SUPPLEMENTAL REPORT TO THE HEARING OFFICER

PROJECT NUMBER: 2019-000010

PROJECT LOCATION: 24937 Mulholland Highway, Calabasas

Re: Response Letter to Cold Creek Community Council (CCCC) to LA County Regional Planning Department
Project No. 2019-000010-(3)

- A. Revised Project Plans (Lots 3 and 4)
- B. Nearby Study Area Map of existing residential building SF

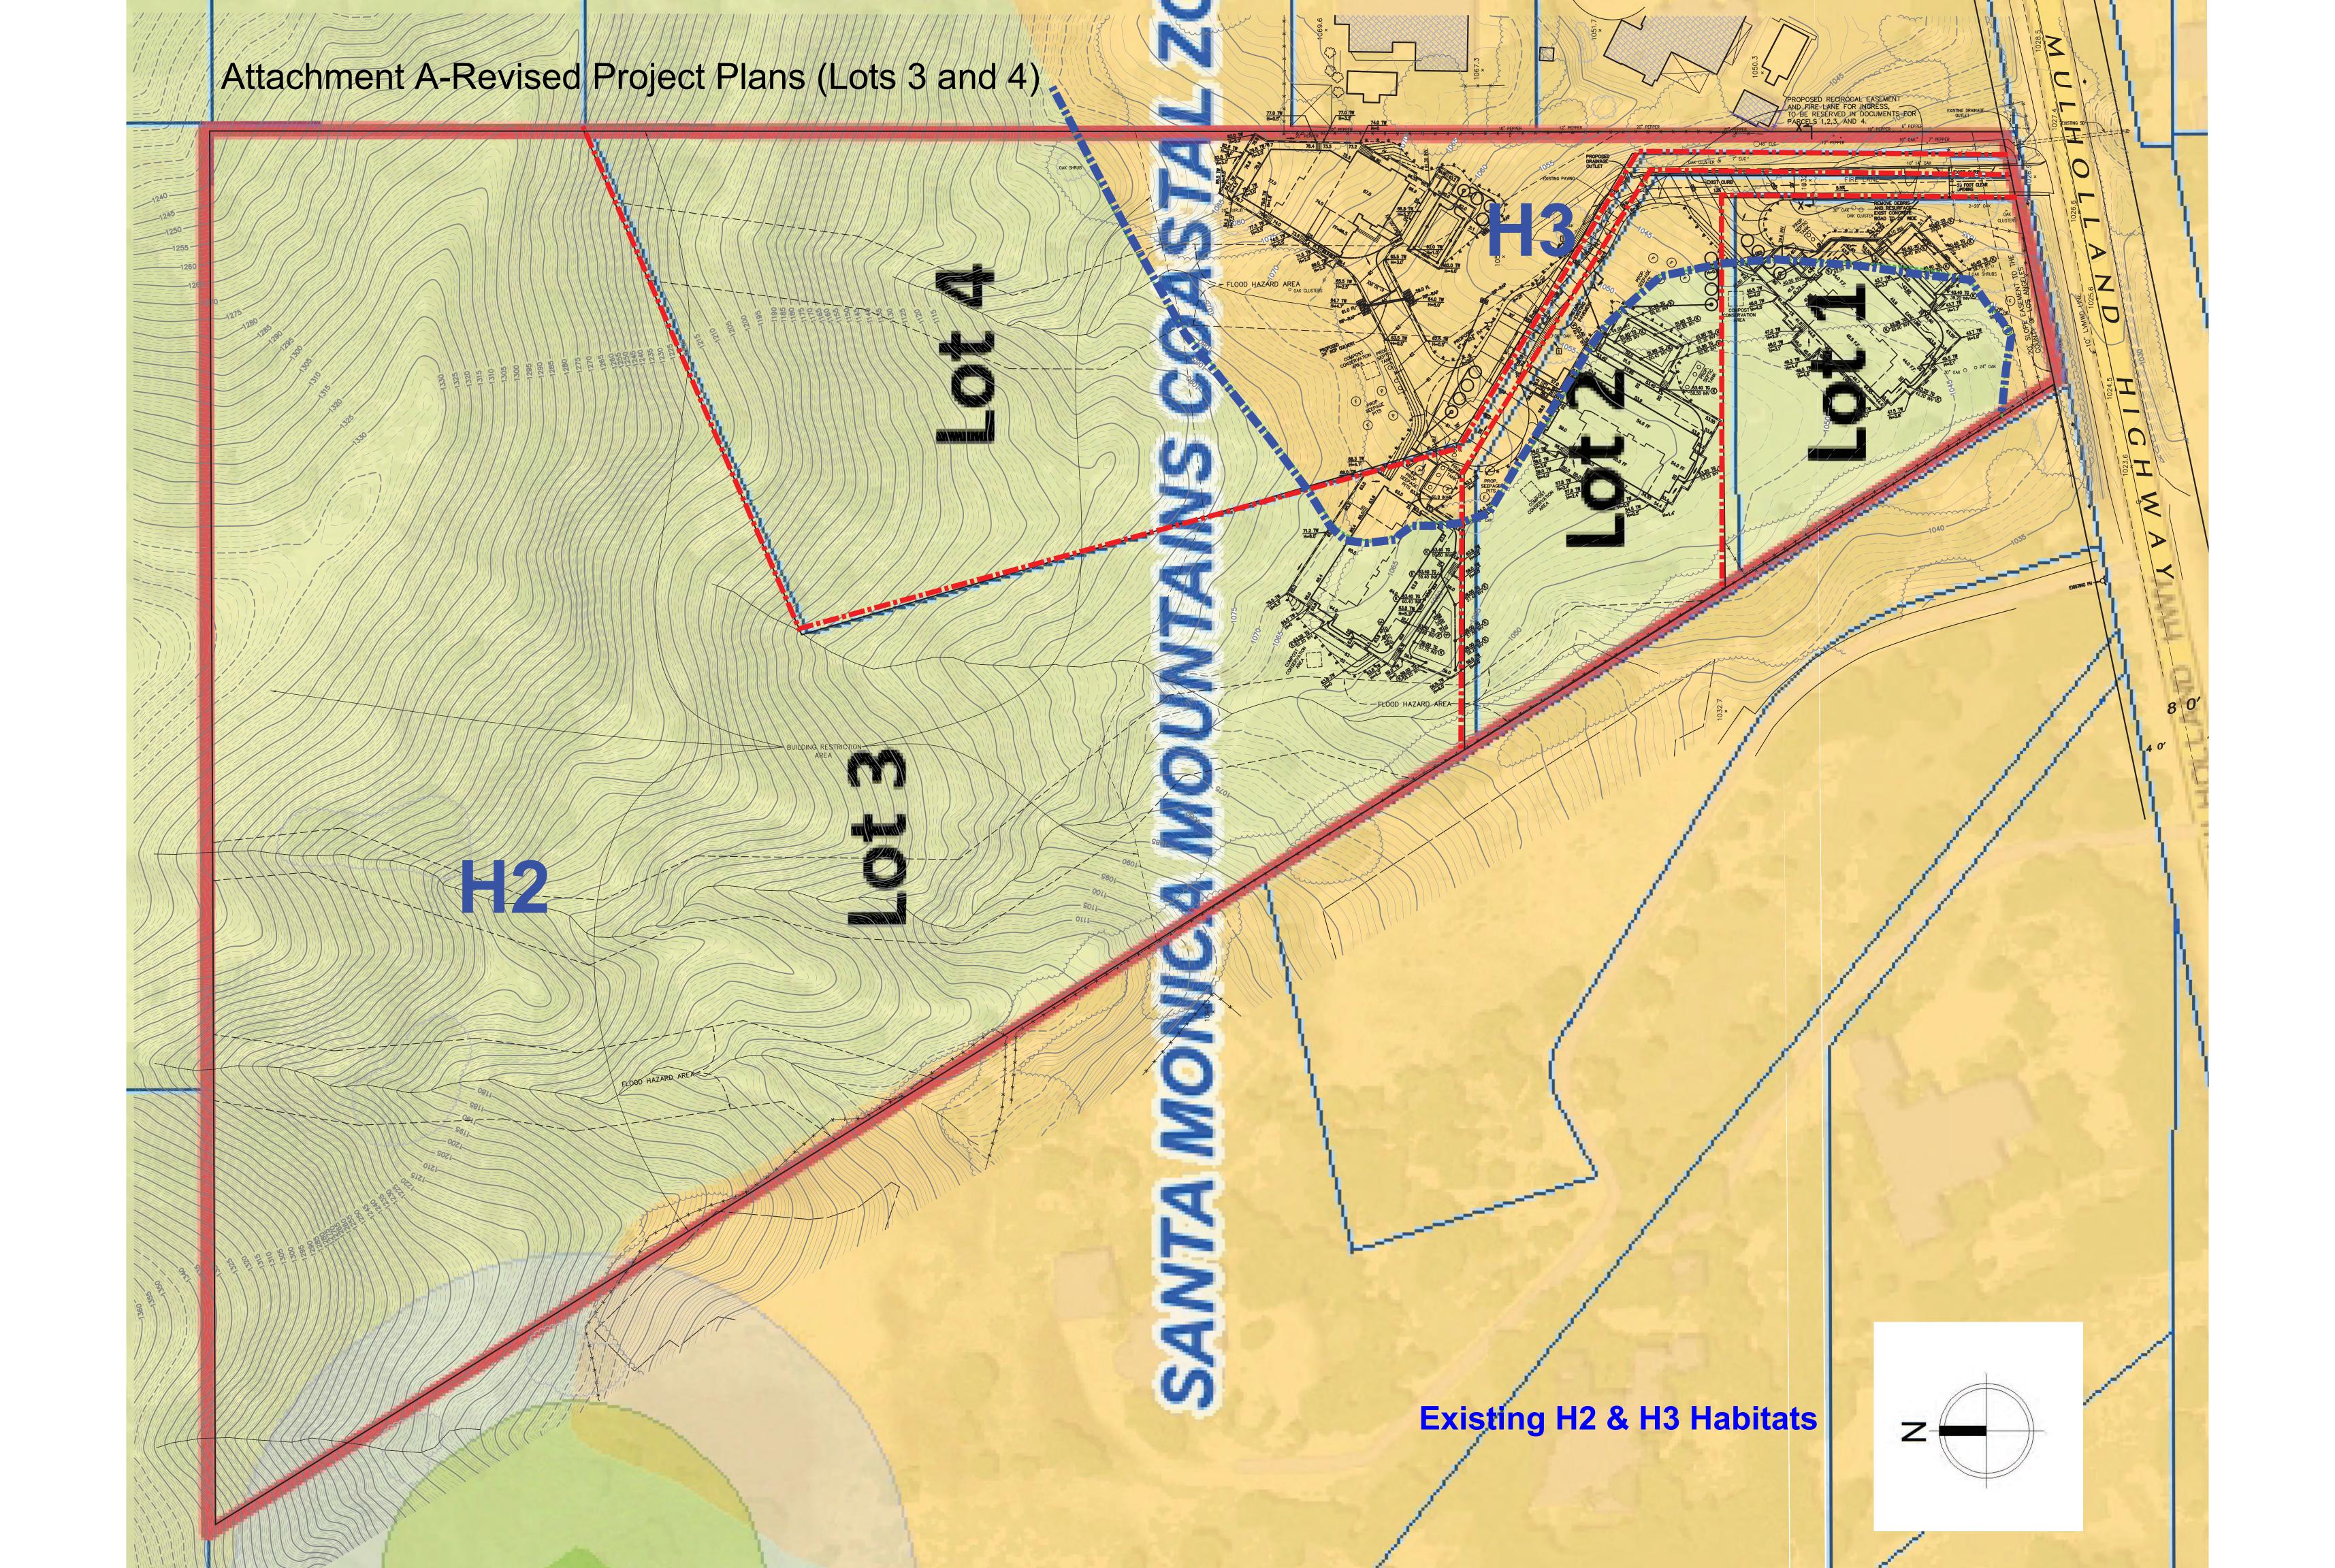
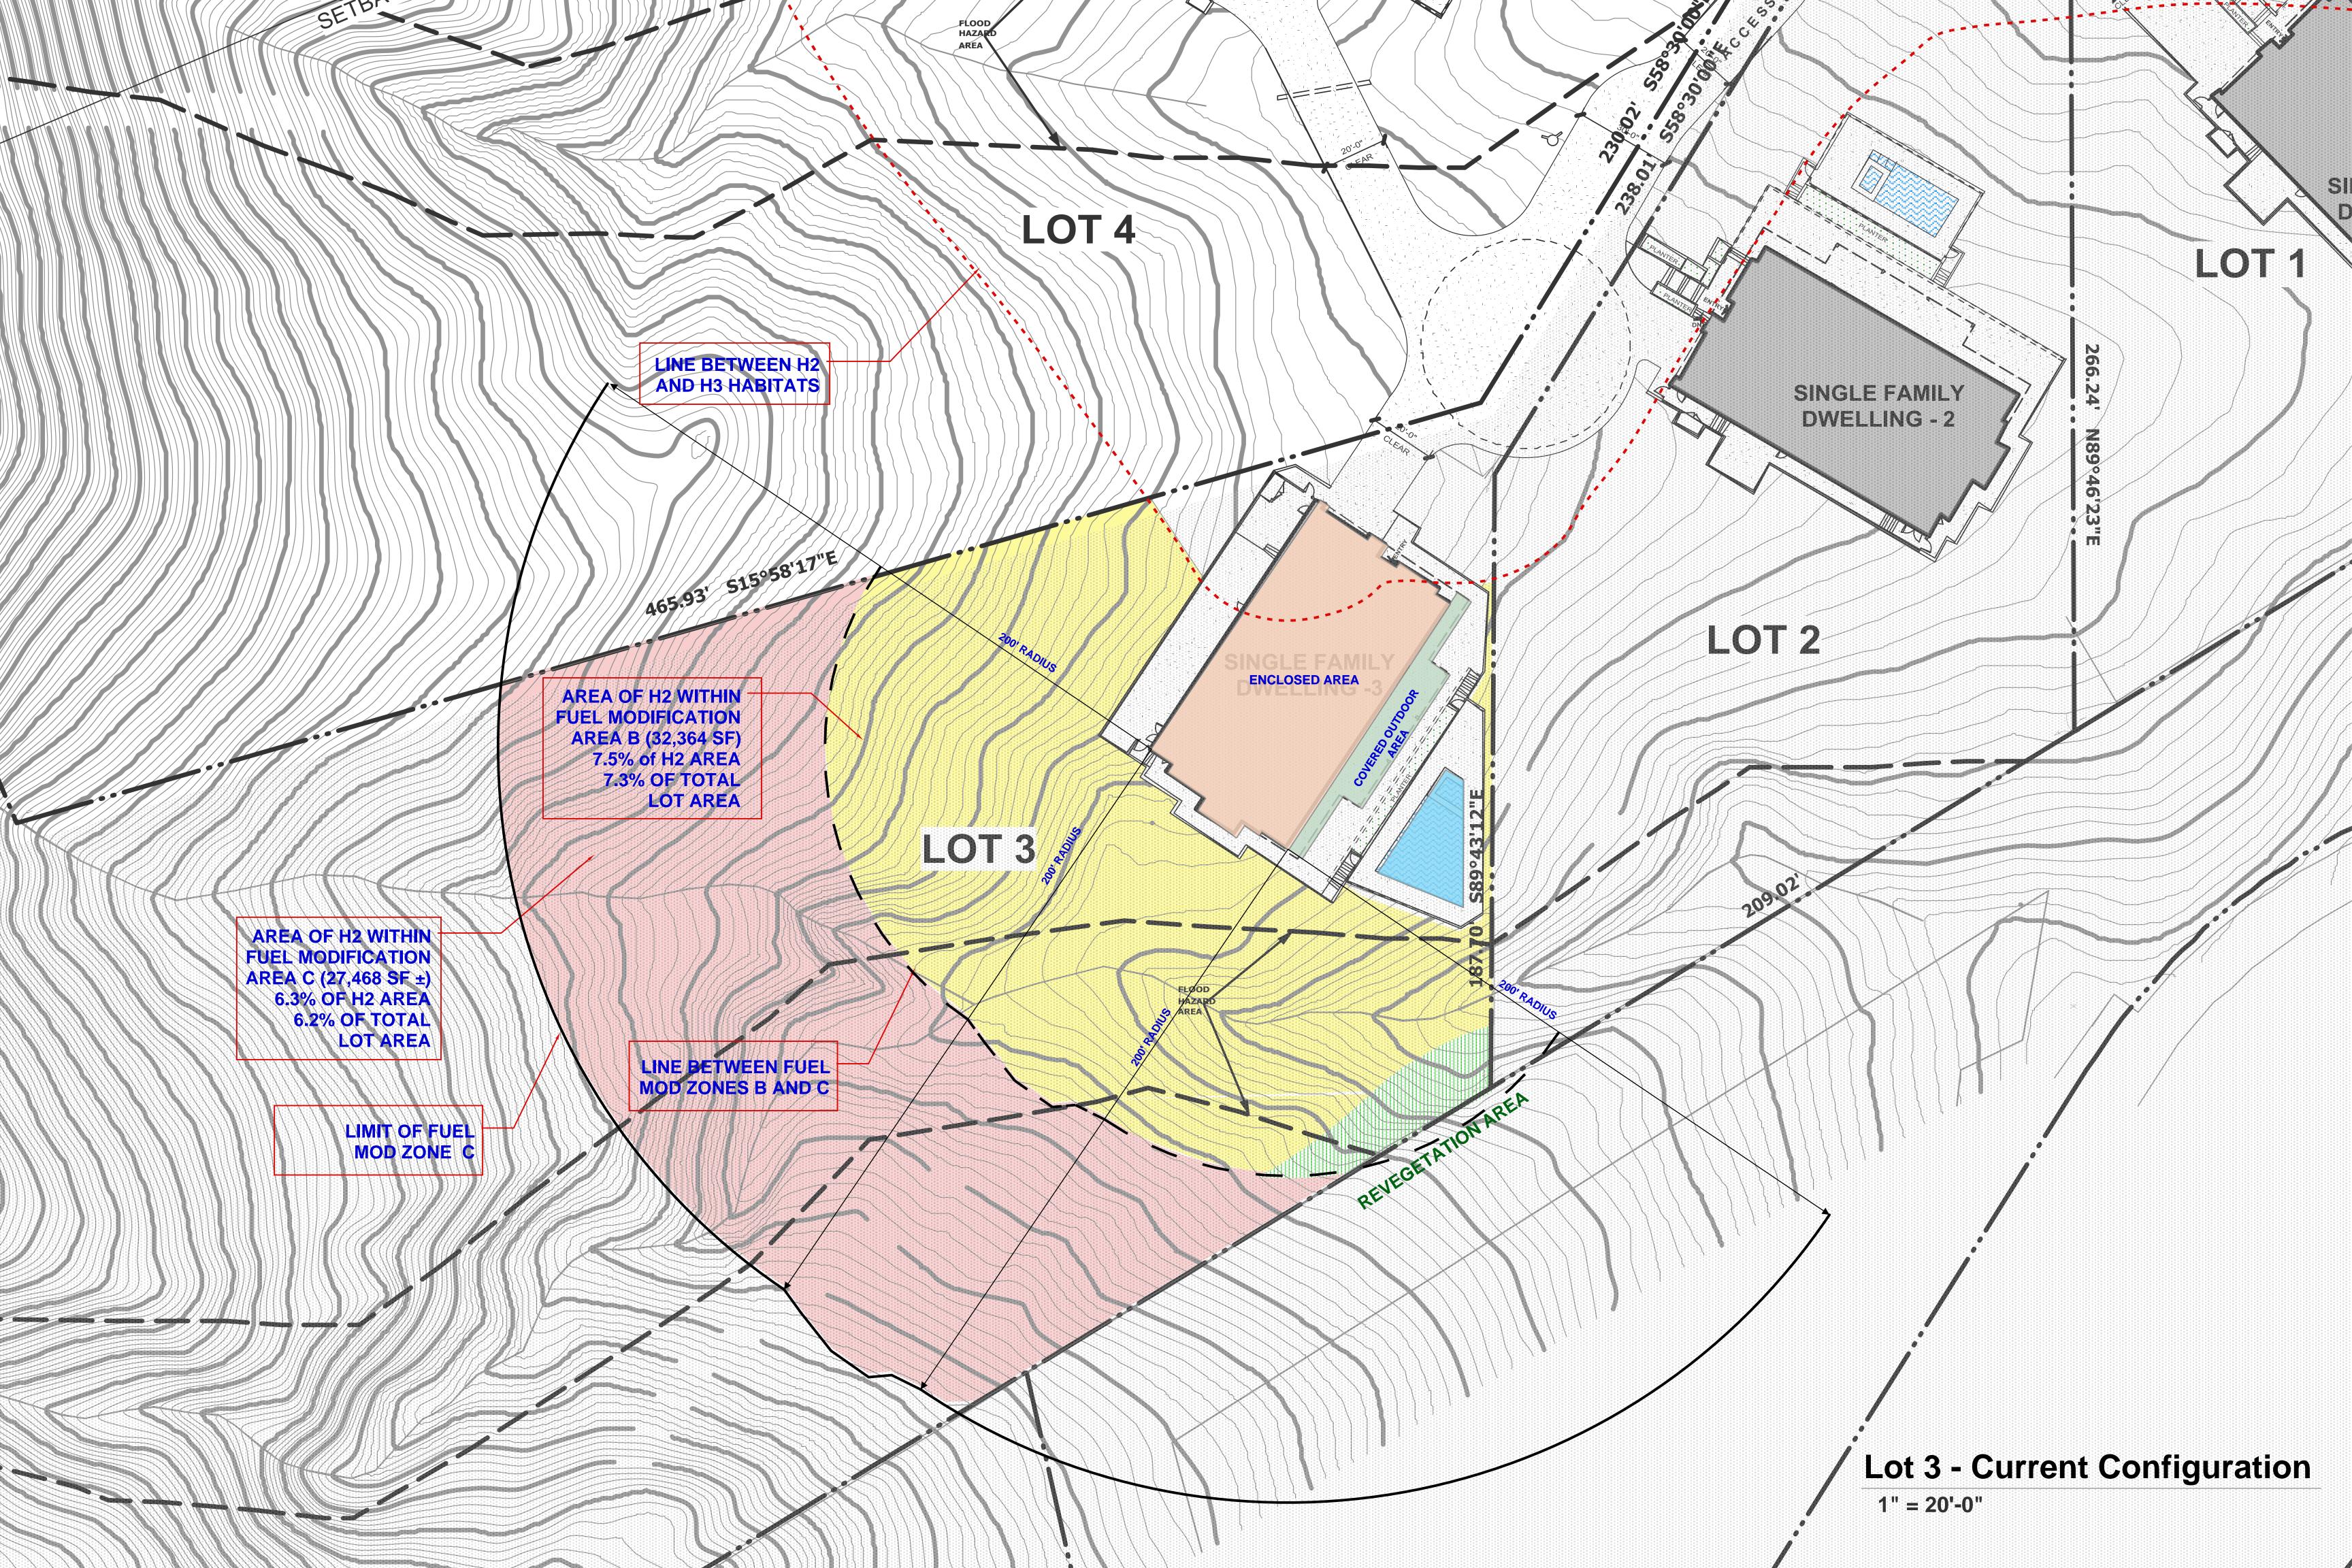
Lot 3 (APN: 4455-019-046): The residence is proposed to be reduced in size by 20% in building footprint at the rear of the building pad, reducing the total size of the residence from 4,114 square feet ("Original Lot 3 Design") to 3,291 square feet ("New Lot 3 Design"). The reduction in footprint greatly impacts the amount of H2 habitat that is preserved and to fuel modification zones B and C. The lot size is 442,134 sf (10.15 acres) and the existing H2 area on Lot 3 is 430,695 sf (9.89 acres).

Lot 4 (APN: 4455-019-047): The residence is proposed to be relocated and shifted southward from its originally proposed location while maintaining the same size and therefore reducing impacts to fuel modification zones B and C and reducing the amount of disturbance in the H2 habitat area (5,717 sf differential) from 35 % to 29.5%. The relocation of the residence also minimized impacts to the existing floodplain/hazard area to the west and location and distance to the lot 3 residence. The lot size is 166,934 sf (3.83 acres) and the existing H2 area on Lot 4 is 104,729 sf (2.4 acres).

Original Lot 3 Design	New Lot 3 Design
House Size	4,114 sf	3,291 sf
H2 Habitat Total Affected (sf)	64,096 sf	59,832 sf (4,264 sf
		reduction)
% of H2 Area Impacted	14.5%	13.89%

Original Lot 4 Design	New Lot 4 Design
House Size	4,186 sf	4,186 sf
H2 Habitat Total Affected (sf)	36,663 sf	30,946 sf (5,717 sf
		reduction)
% of H2 Area Impacted	35%	29.5%
